# Staff Summary Report

**SUBJECT:** Hold a public meeting for a Development Plan Review for RCI SYSTEMS BUILDING ADDITION located at 1220 West Geneva Drive.

**DOCUMENT NAME:** DRCr\_RCI-Systems-Add\_100907

**DPR07184** – Development Plan Review including site plan, building elevations, and landscape plan.

ARCHITECTURAL SITE PLAN

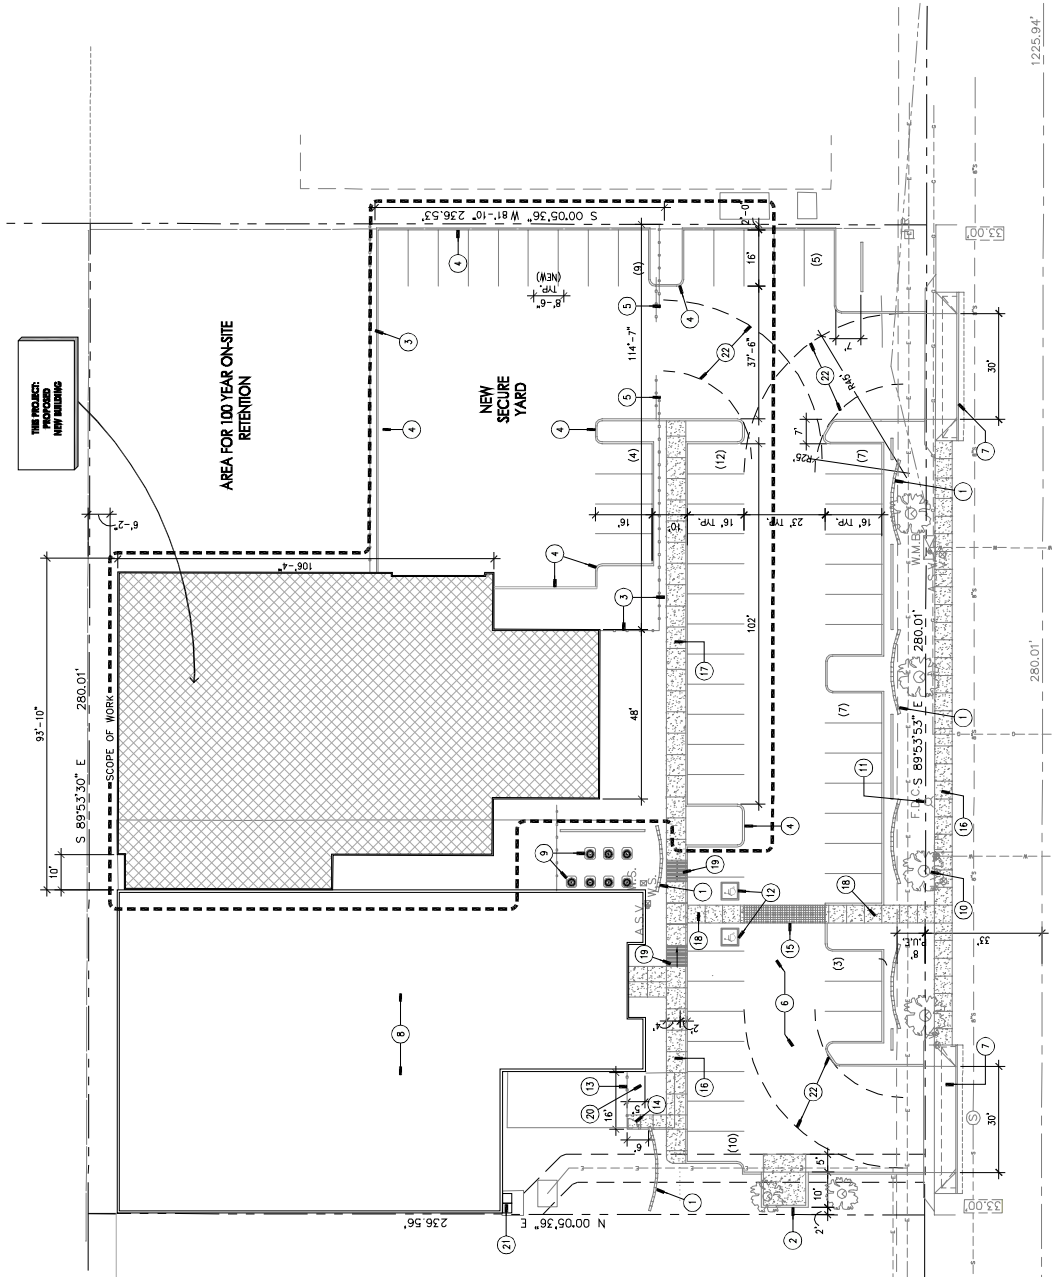
3. Remove existing slatted chain link fence on-site at east and north property lines. Replace existing fence with steel vertical picket fence at minimum 6'-0" height from grade. Limit horizontal rails to one top and one bottom to inhibit climbing. Provide maximum 0'-4" clearance between pickets. Minimum extent of fence as follows: from Northeast corner of addition, across swale north to north property line; east along north property line east to northeast property corner; and south along east property line to northeast corner of secure yard.

4. Enclose service yard east of the addition with wall of minimum 8'-0" high masonry. Where materials are stored in the yard, increase the height of the masonry wall as needed to match the height of the stored items, up to a maximum of 10'-0". A steel vertical picket cap on top of the service yard masonry wall is acceptable as long as the masonry itself without the cap is minimum 8'-0" high. Exceptions to the 8'-0" service yard masonry wall at the perimeter of the yard are allowed as follows:

6. Provide a minimum 10'-0" wide landscaped island on the east of the roll gate, where one side of the gate/fence has a minimum 7'-0" wide by full length of parking space landscape area.

7. Locate additional electrical service entrance section inside the building, in a flush fitting alcove at the surface of the building or inside the enclosed service yard.

- Parking spaces:
    - Modify parking calculation. Include storage mezzanine in calculation of vehicle parking. Verify quantity of disabled accessible parking is adequate for the enlarged parking quantity. Indicate required and provided bicycle parking.

3  
 1220  
 1/8" = 1'-0"  
 REAR ELEVATION (NORTH)

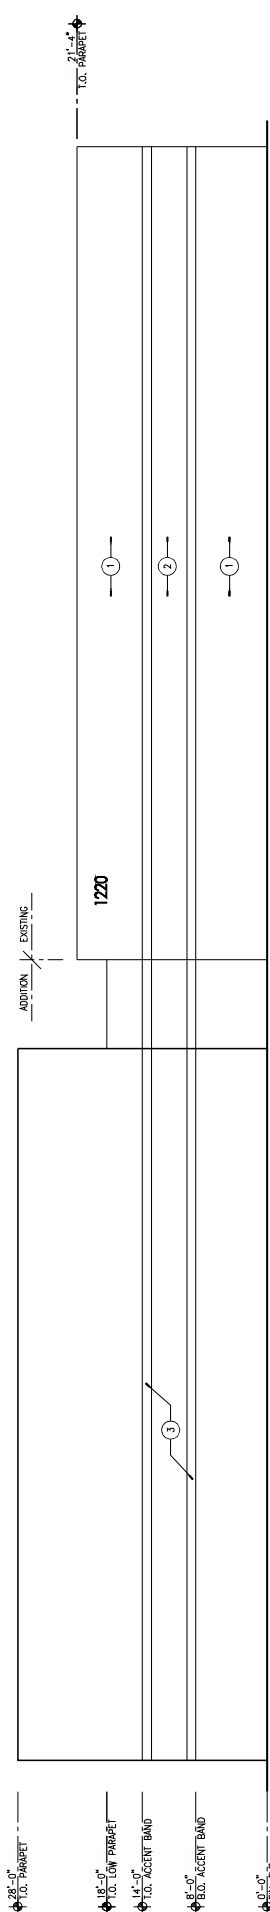
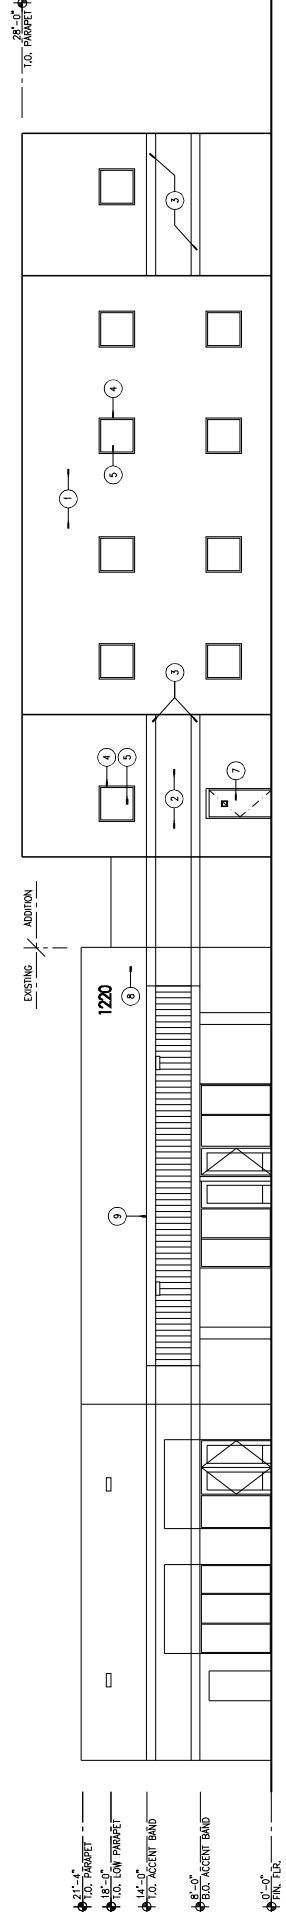
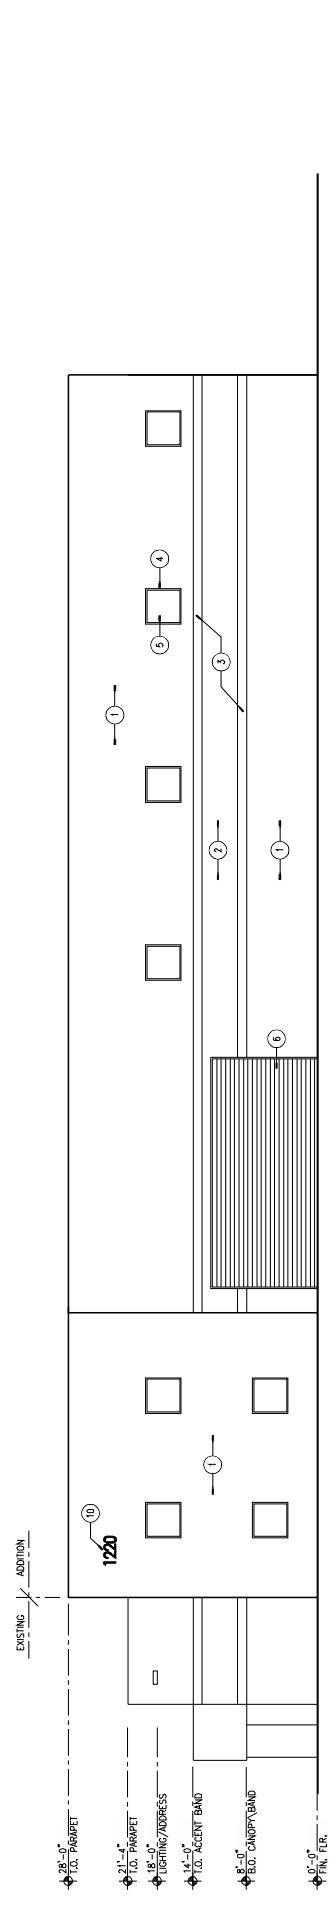
12. Provide painted stucco finish on masonry field and accent band similar to existing building. Revise notes that indicate the building exterior finish is paint direct applied to masonry.

14. Provide roof access that is fully concealed on four sides, including full concealment of external ladder from lower to upper roofs. If external ladder cannot be concealed, or if parapet opening at top of ladder exposes roof-mount mechanical equipment, replace external ladder with roof scuttles to each separate roof.

15. Indicate design of exposed roof drainage system, including metal components that are painted to match the adjacent exterior plaster field and accent colors. Match design of roof drainage system of existing building to that of the addition.
